**STAFF REPORT:** 11/10/2021 MEEETING

**ADDRESS:** 8016 KERCHEVAL

**APPLICATION NO:** #21-7581

**SCOPE:** ERECT DECK BETWEEN EXISTING FRONT PORCHES; REPLACE WINDOW WITH DOOR; INSTALL ADA LIFT AT REAR PORCH; AND ERECT DUMPSTER ENCLOSURE IN PARKING LOT

**EXTERIOR  
 REAR DECK +  
 ELEVATOR LIFT**

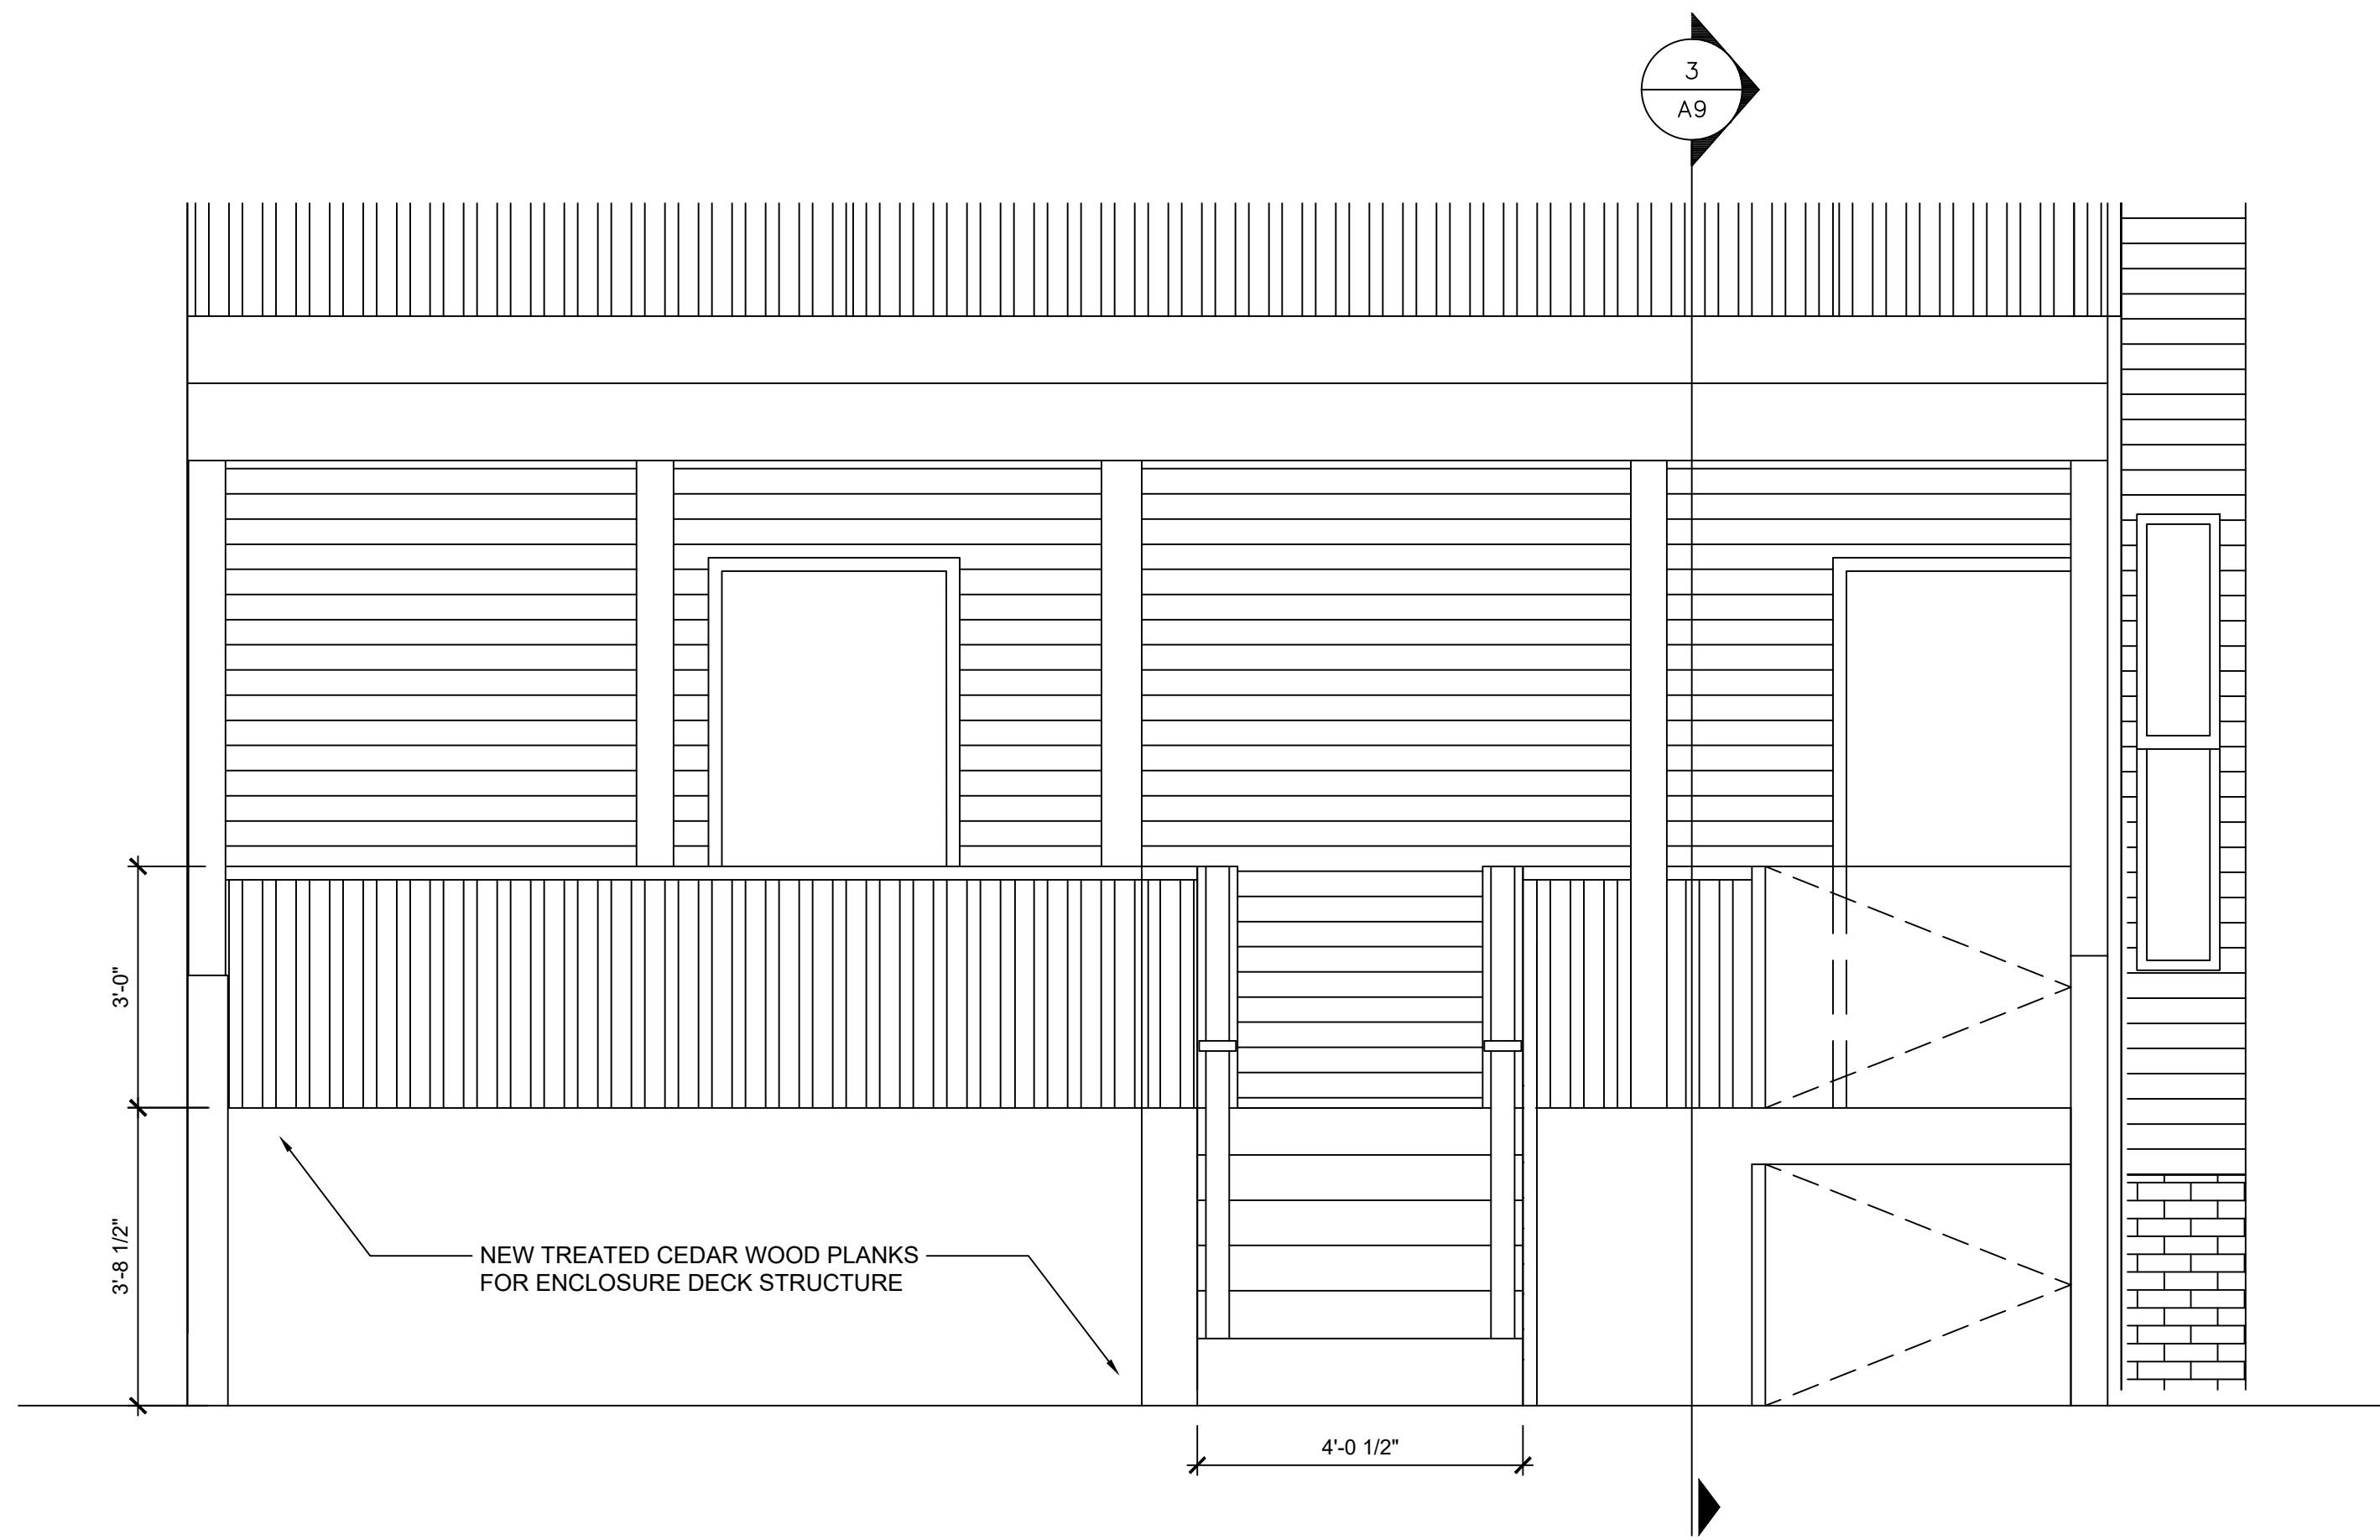
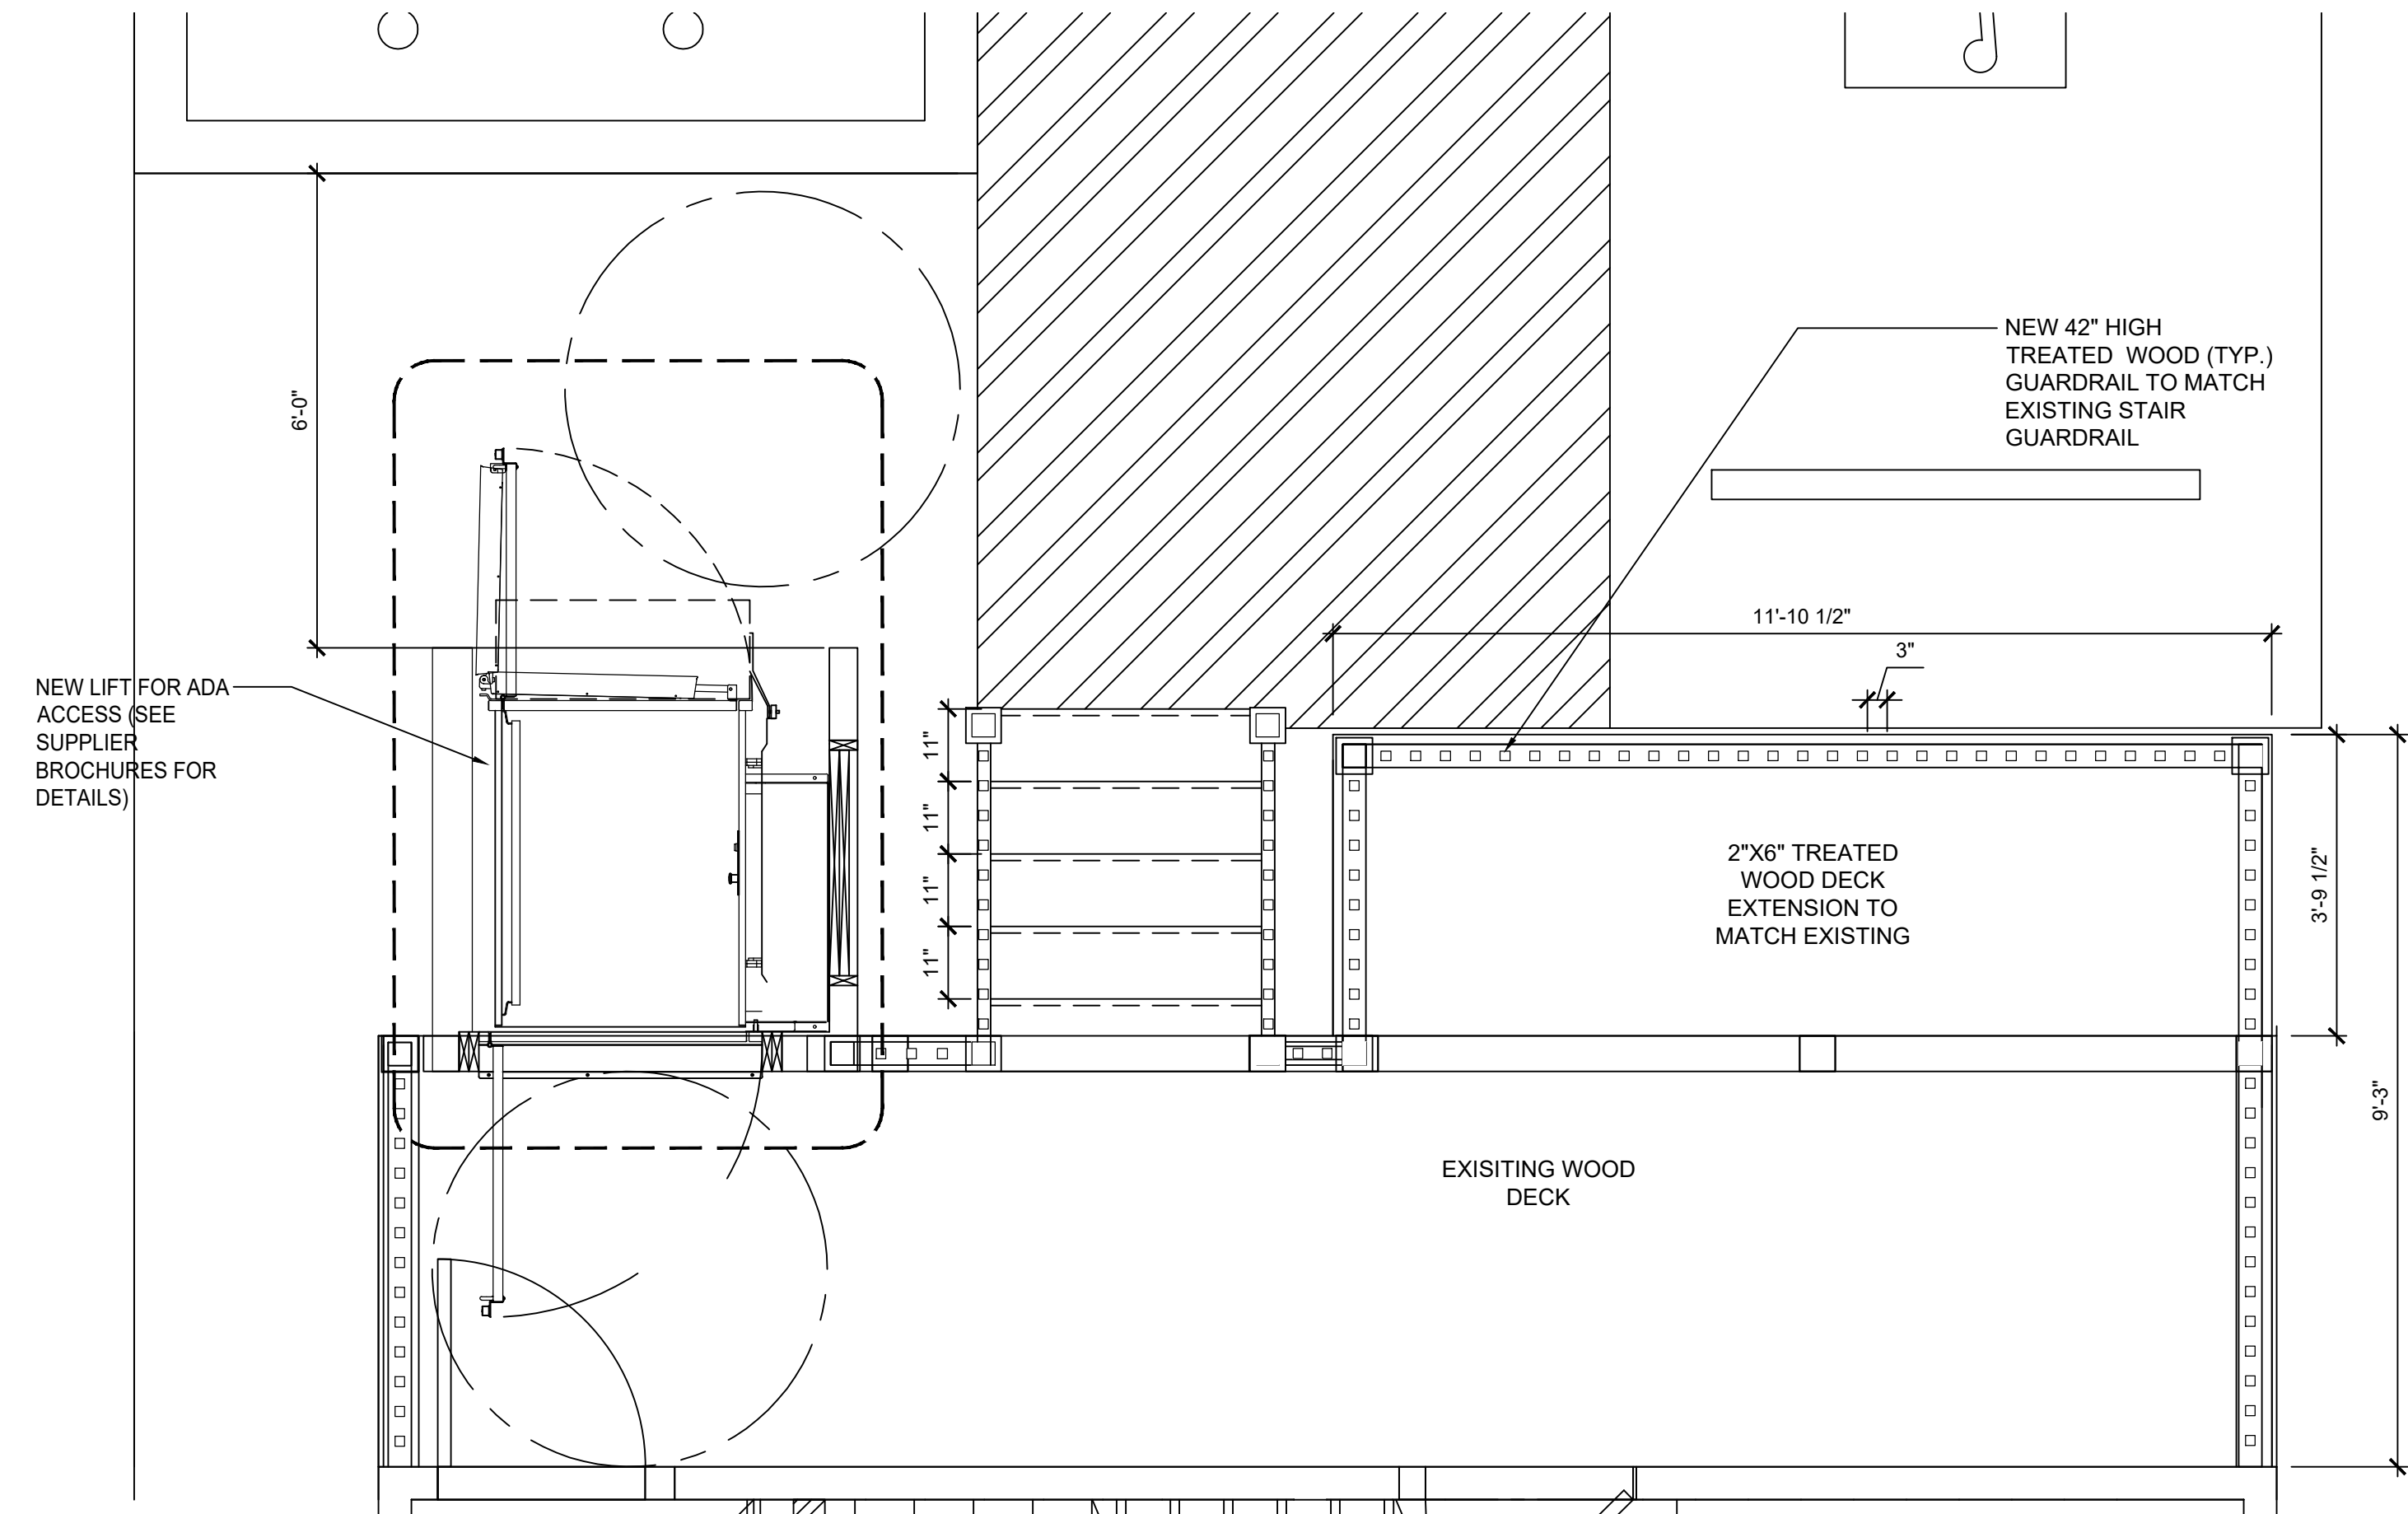
- The rear porch proposed for revision is not visible from the public right-of-way and was erected sometime between 2017 and 2018. It is staff's opinion that the work proposed at the rear porch meets the Standards and will not result in the removal of historic fabric and/or significant character-defining elements at the building.

- The applicant shall stain or paint the rear deck, a color which complements the building's trim color. The applicant shall provide a color palette for the deck to HDC staff for review and approval prior to the issuance of the project permit.
- The applicant shall indicate the final location of the two existing gas meters prior to the issuance of the project permit.
